Government of India
Ministry of Environment, Forests and Climate Change
(Forest Conservation Division)

Dated: 12th April, 2021

Sub: Diversion of 109.459 ha of forest land for Open Cast Mining Project at Gourangdih ABC coal mine in favour of WB Mineral Development and Trading Corporation under Durgapur Forest Division, West Bengal.

Google Imagery dated 07.09.2015 showing the Non-forestry activity on the eastern boundary of Gourangdih 'C' Coal block

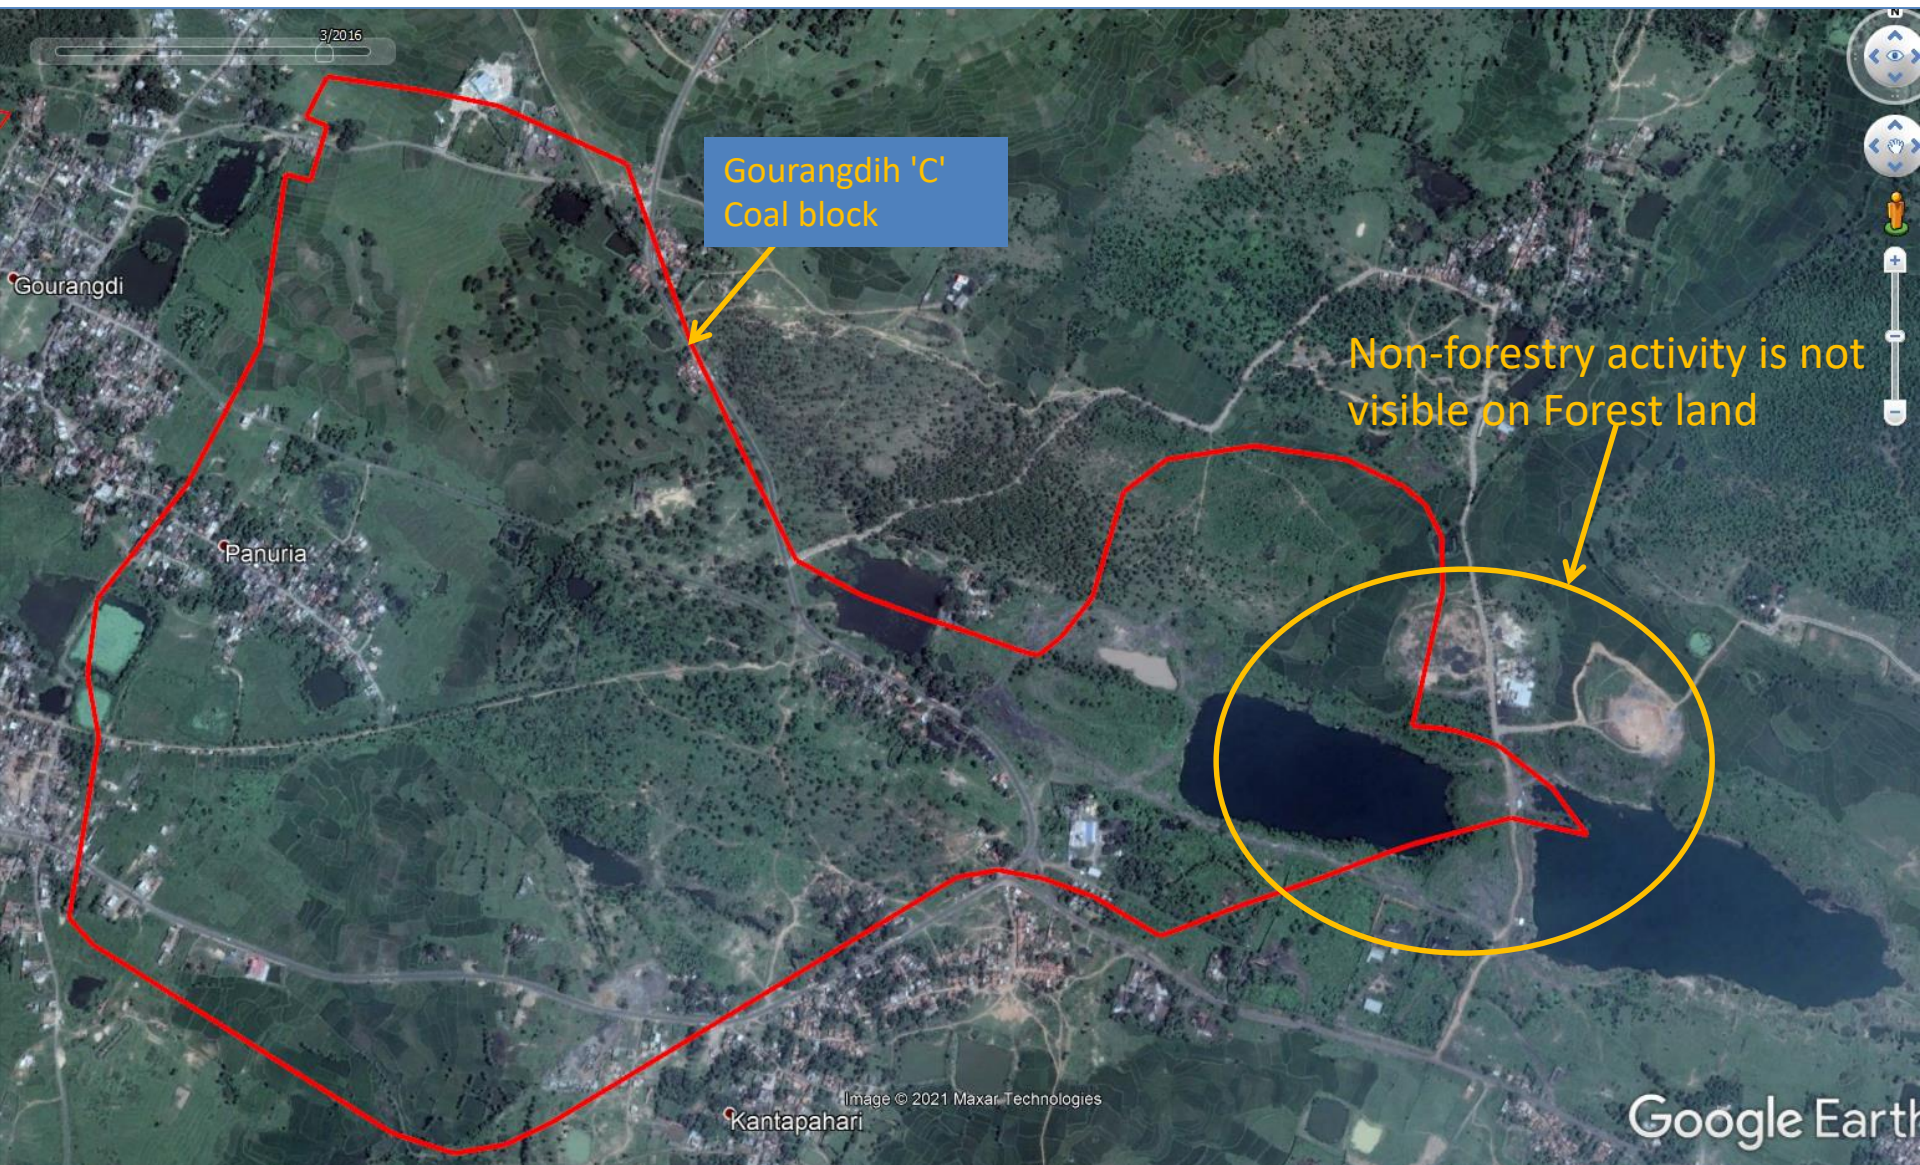
1. From the perusal and analysis of the KML files submitted by the State Government it is observed that some Non-forestry activity/ mining in the proposed Forest land has been noticed on the eastern boundary of Gourangdih 'C' Coal block. It is also observed through DSS tool that many forest patches specifically in the Gourangdih 'C' Coal block boundary in the proposed area of diversion has not been included. In this regard, Maps are enclosed for your ready reference [**Annexure-I (a to d)**].

DSS Map showing the Forest Patch on the eastern boundary of Gourangdih 'C' Coal block not taken into consideration during the DGPS survey and thus left and does not become part of instant proposal

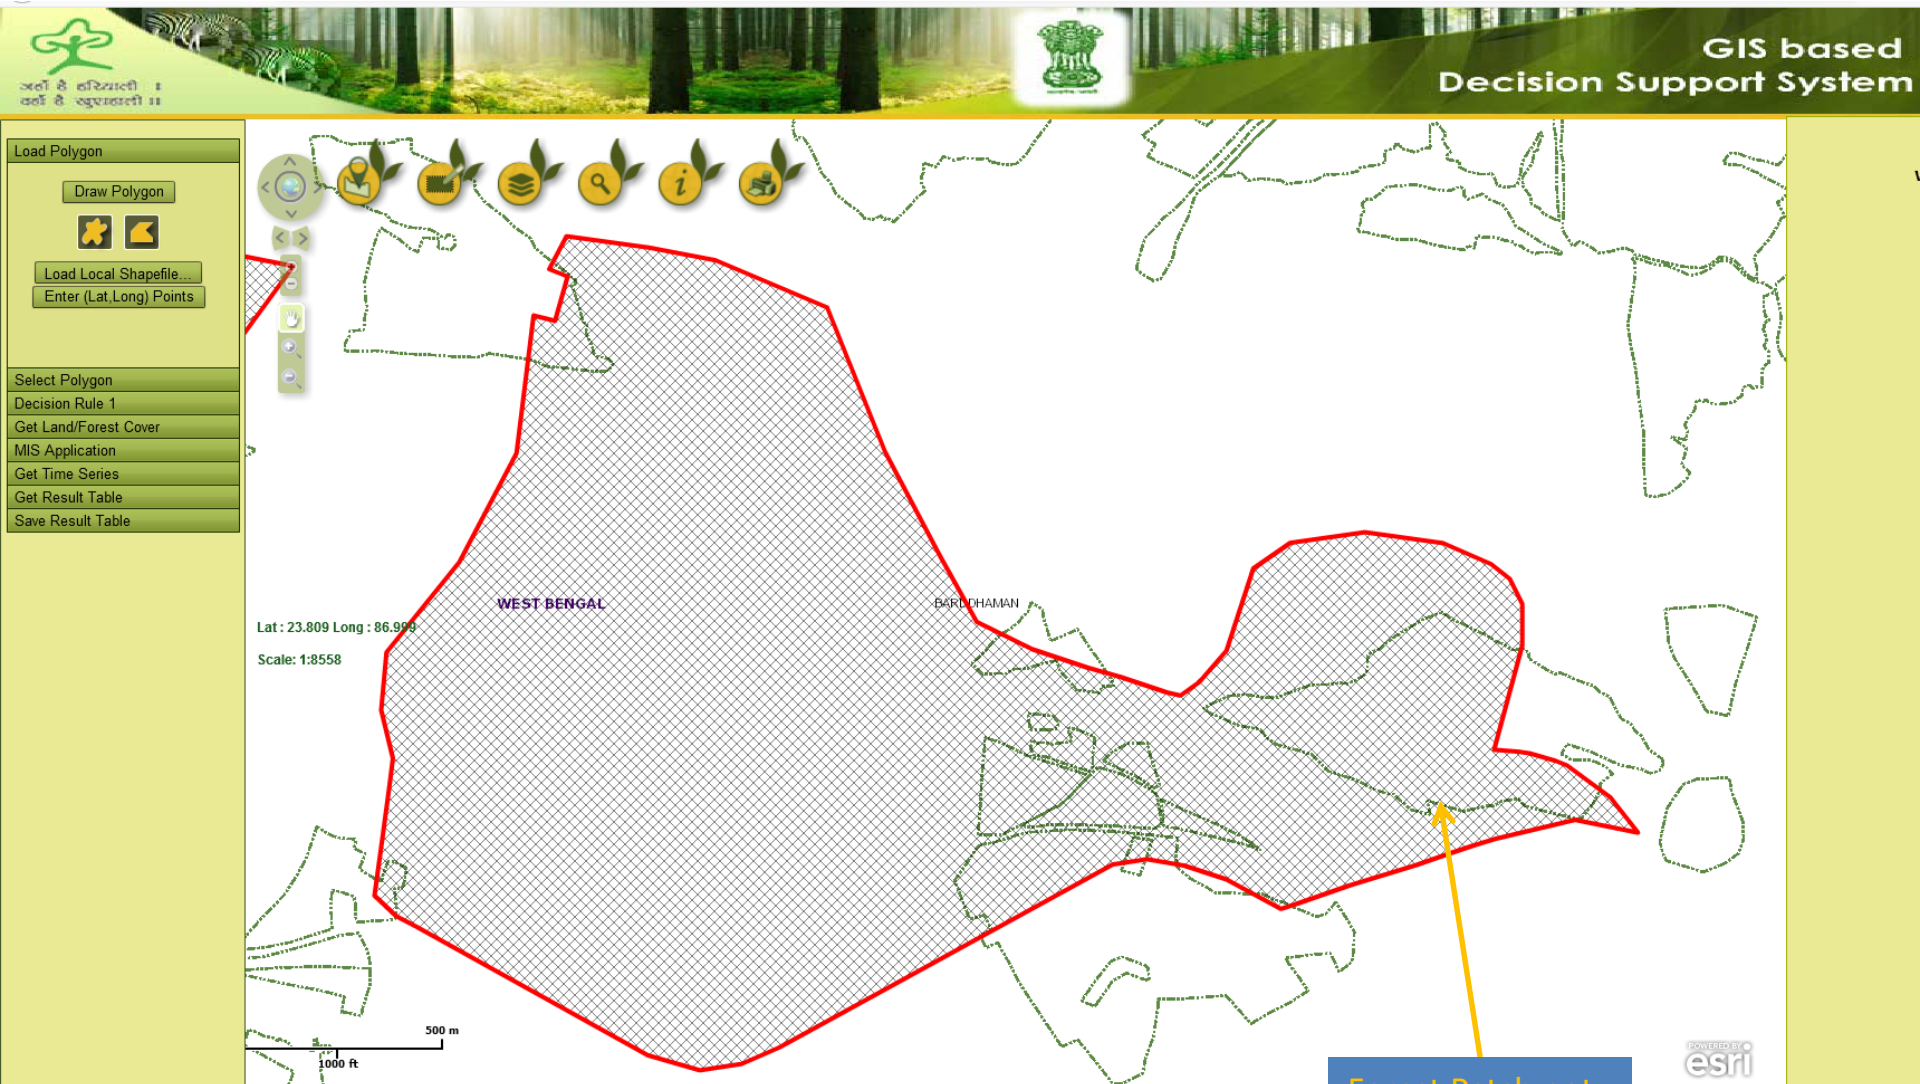
Forest Patch not taken into consideration

DSS Map Showing Part of Survey No/Khata No 281 falling on the Forest compartment boundary

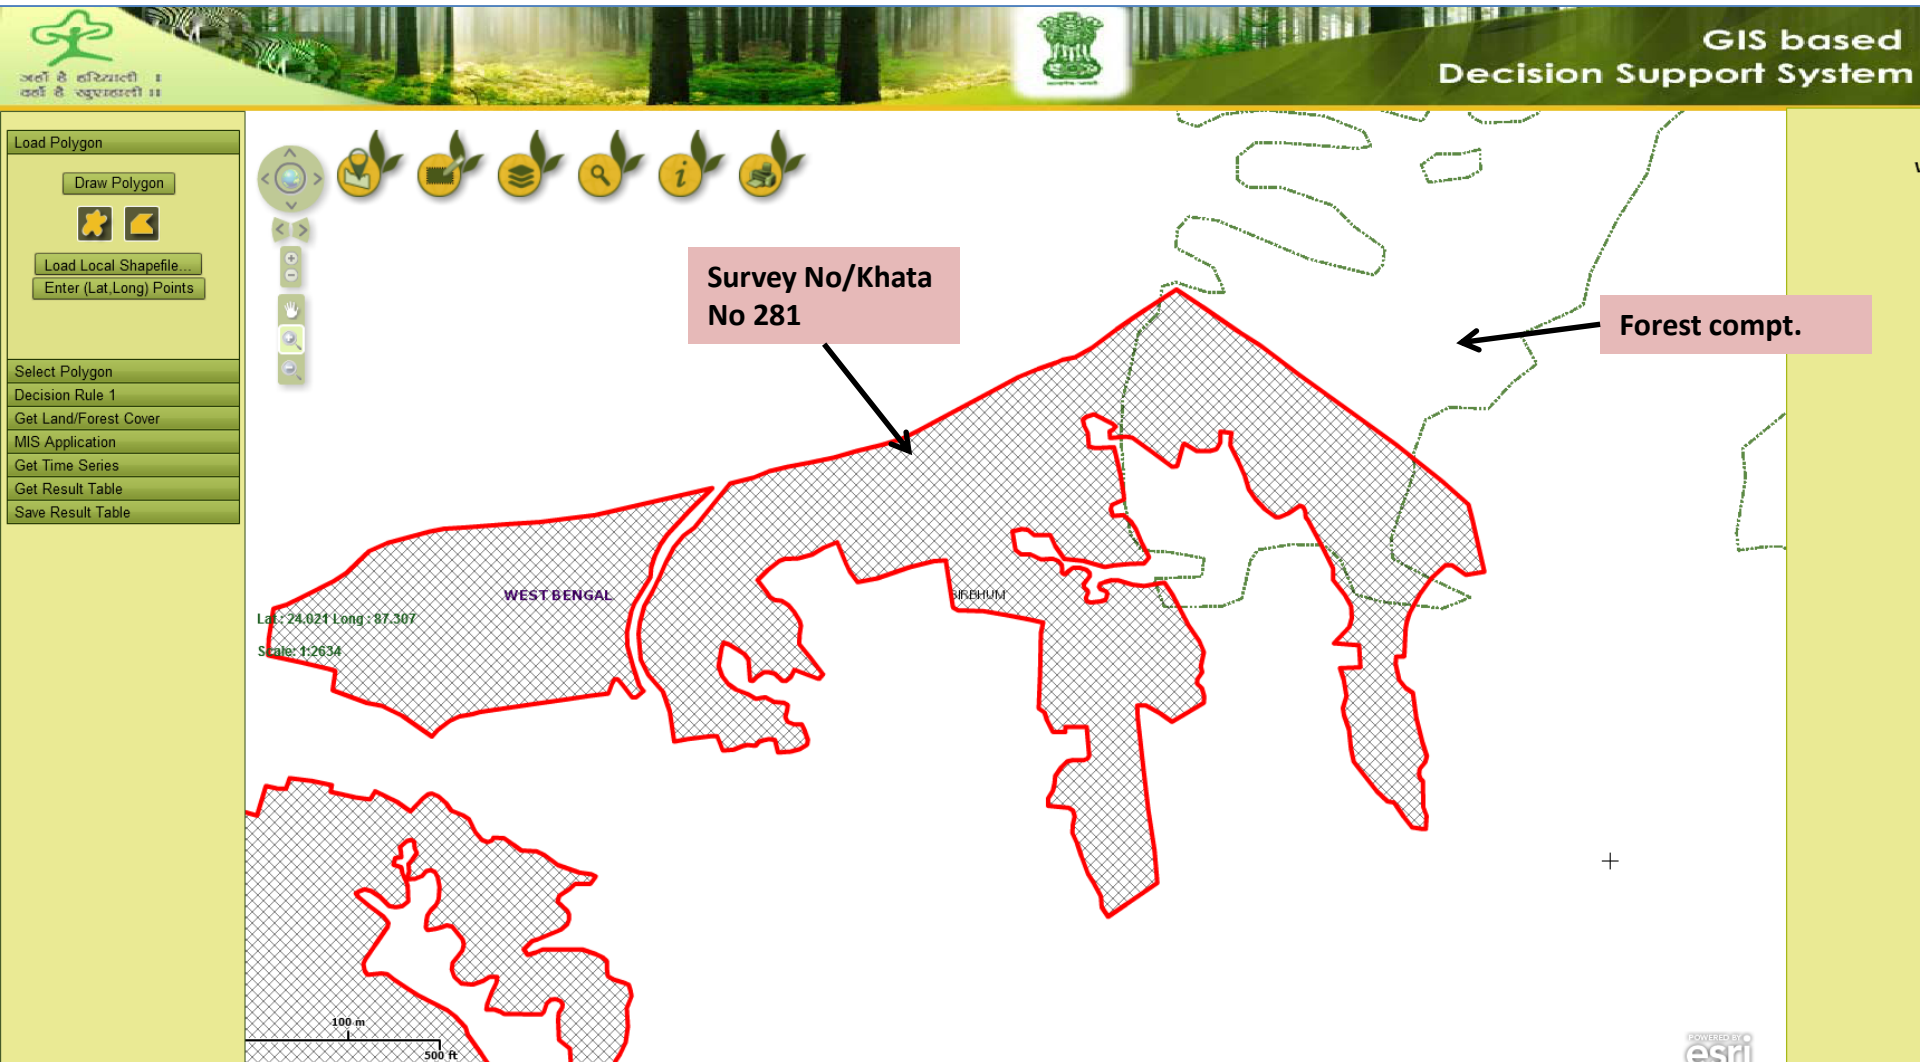
2. Ministry vide its letter of even number dated 15.07.2019 has requested to revise the proposed CA sites proposed on Plot Nos. 281, 1580, 306 & 358 which are falling on the Forest compartment boundaries instead of non-forest Govt. land as mentioned in the proposal and the encroachment in the form of agricultural land is also observed through Google earth Imagery dated 4/1/2019 in the proposed CA patches bearing Plot Nos. 253, 1863, 73, 48, 1840 & 1841". In its compliance the state government has not changed the CA sites. The discrepancies in proposed CA are reiterated as under:

- a. Survey No/Khata No. 525, 306, 358, 3, 281 1580 and 1300 are falling in the Forest compartment.

Google Imagery dated 05.01.2021 showing presence of Settlements inside CA patch having Survey No/Khata No. 1152

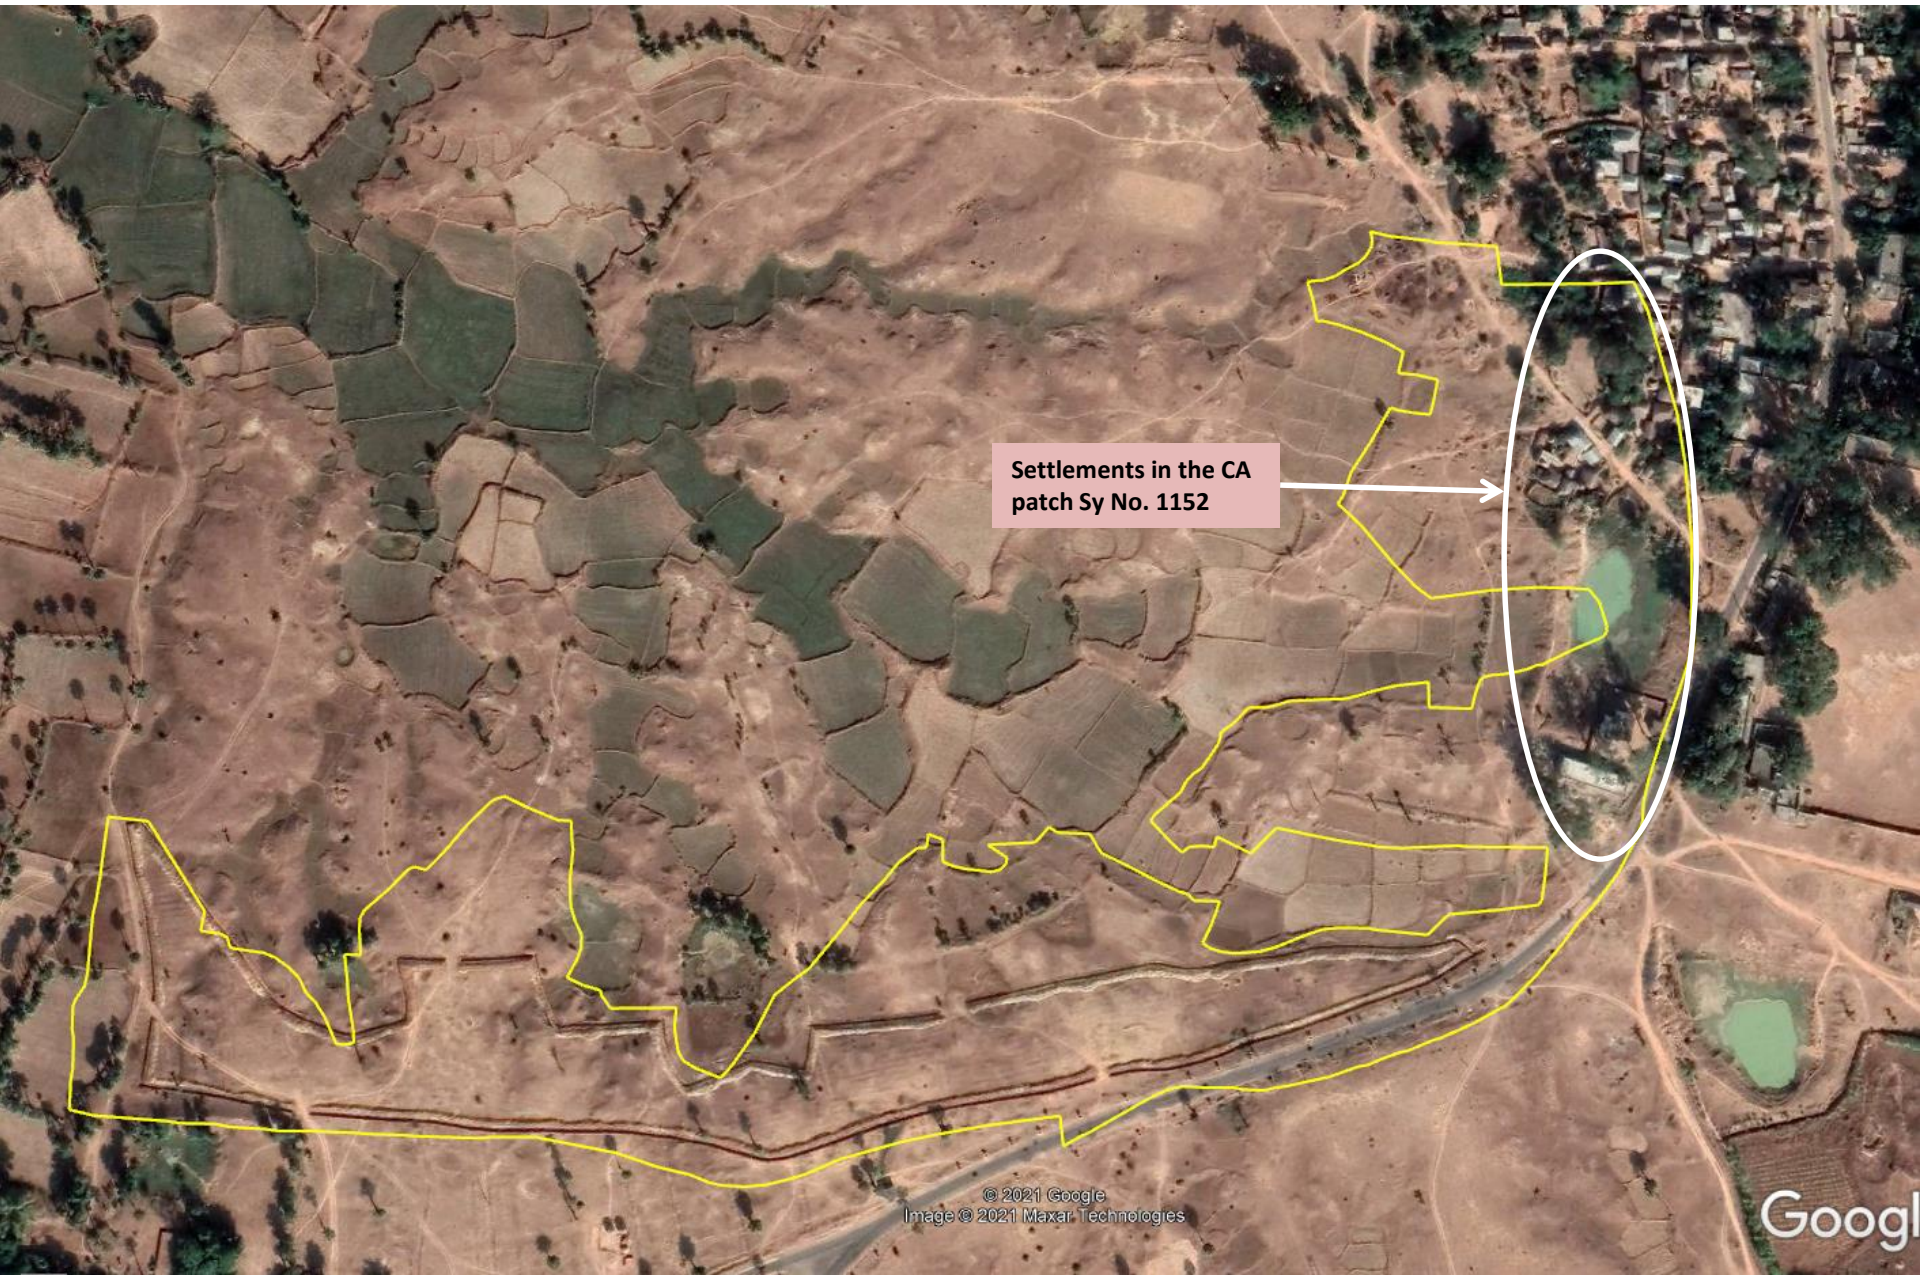
- b. Survey No/Khata No. 1152 is having some Settlements.
- c. Survey No/Khata No. 561 (8.21 Ha) is having pre- plantation work.

Settlements in the CA patch Sy No. 1152
